Reply to Referee Comments

Referee #2:

Fig. 4. Raw seismic signals and rainfall data. (a) and (c) represent monitoring station 1 and station 2 in the Fotangba Gully; (b) and (d) represent monitoring station 1 and station 2 in the Er Gully; (e) Rainfall at Fotangba Gully; (f) Rainfall at Er Gully.

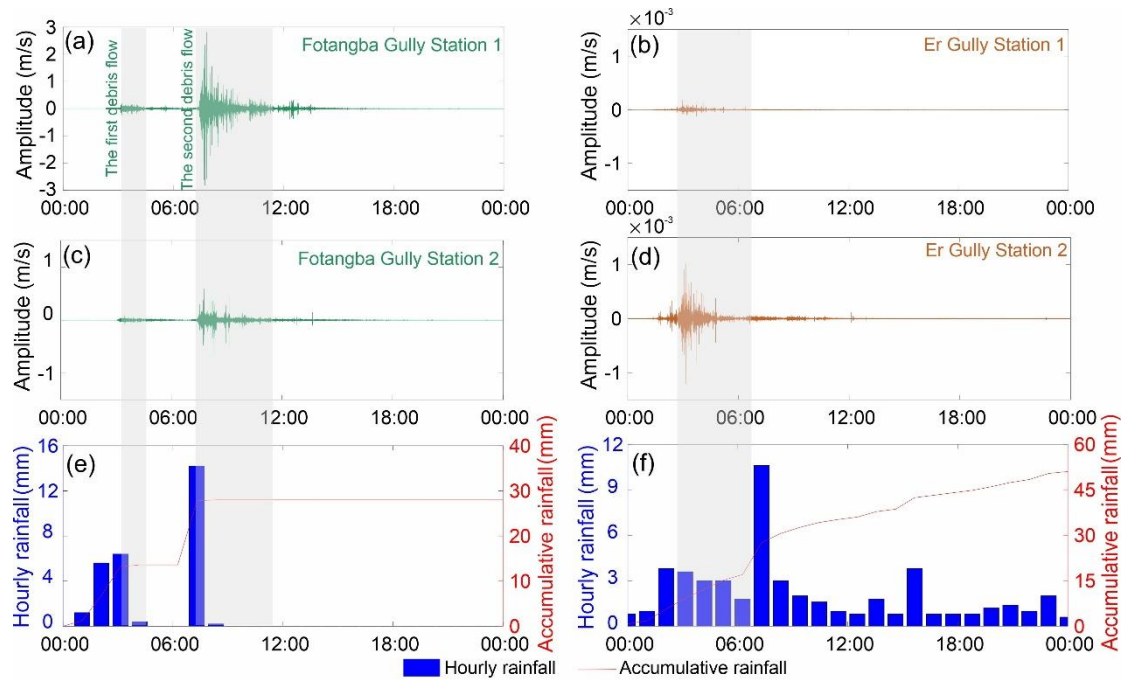
C7: Figure 4. error in captions and lettering in the figure.

- Which station is which panel?

R7: Thank you very much for your valuable comments. We modified Fig. 4, added the station information for each panel.

Fig. 7. Infrared camera images taken and the seismic signal recorded at monitoring

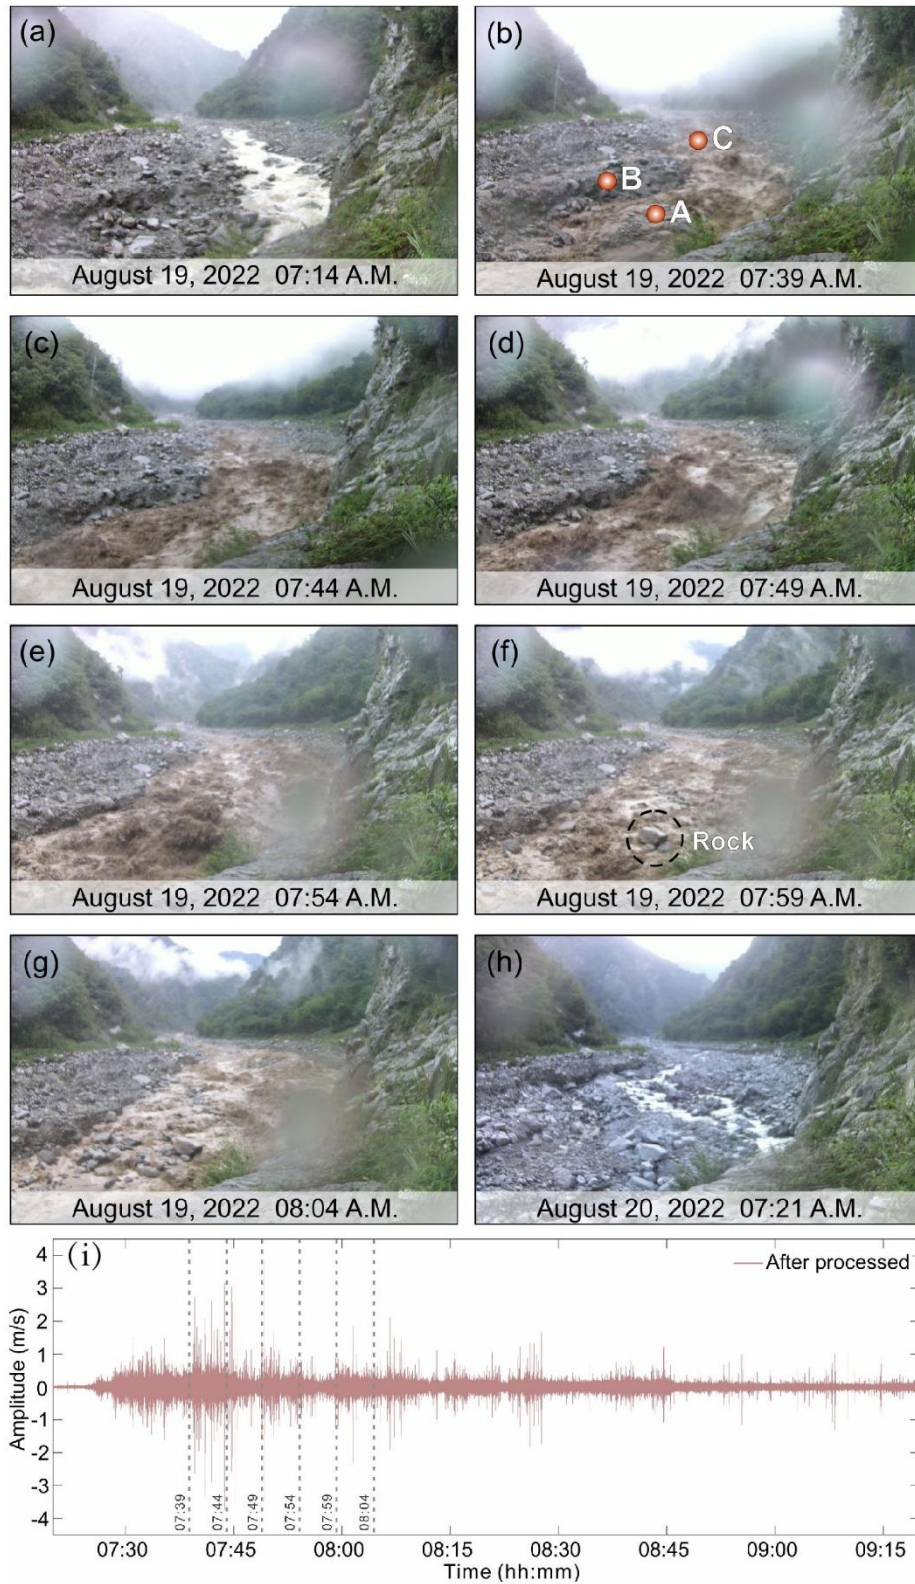
C15: Figure 10: missing caption. Where is (h) and (i)?

R15: Thank you very much for your valuable comments. We have modified the captions in Fig. 10 (Fig. 7).
